FCC Permissive Change 1 Application Letter

FCC ID: R7C-F100

Class II Change: modification of antenna for 850MHz performance.

Mechanical differences between M30 and M35 Antenna Design:

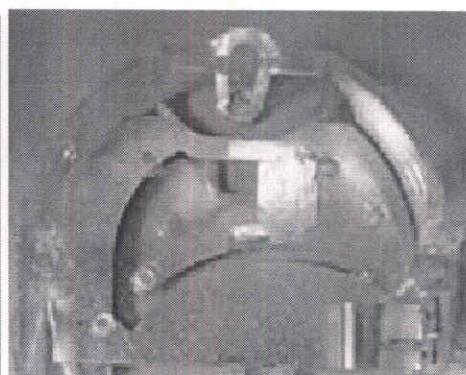
Pictured below is the M30 (left) and M35 (right) antenna. The only difference is the addition of 1.4 mm of material to the vertical slot below. This affects the GSM 850 response only. See Firefly Antenna Differences M30 M35 PCS for details.
